Proposed amendment to document ECE/TRANS/WP.29/GRSP/2012/10 (Proposal for the 02 series of amendments to UN Regulation No. 100)

The text reproduced below was prepared by the experts from RESS and aim to reflect the result of RESS sub-group completely and correct to appropriate wording, i.e. editorial and clarification.

Figure 1

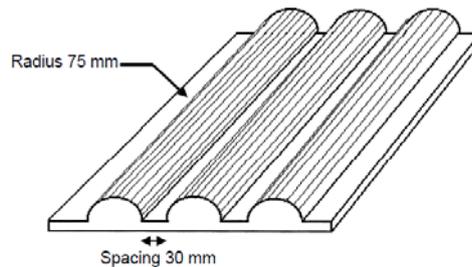
The Tested-Device shall be crushed between a resistance and a crush plate as described in figure 1 7 with a force of at least 100 kN, but not exceeding 105 kN, unless otherwise specified in accordance with Paragraph 6.4.2 of this Regulation, with an onset time less than 3 minutes and a hold time of at least 100 ms but not exceeding 10s.

Dimension of the crush plate:

600 mm x 600 mm or smaller
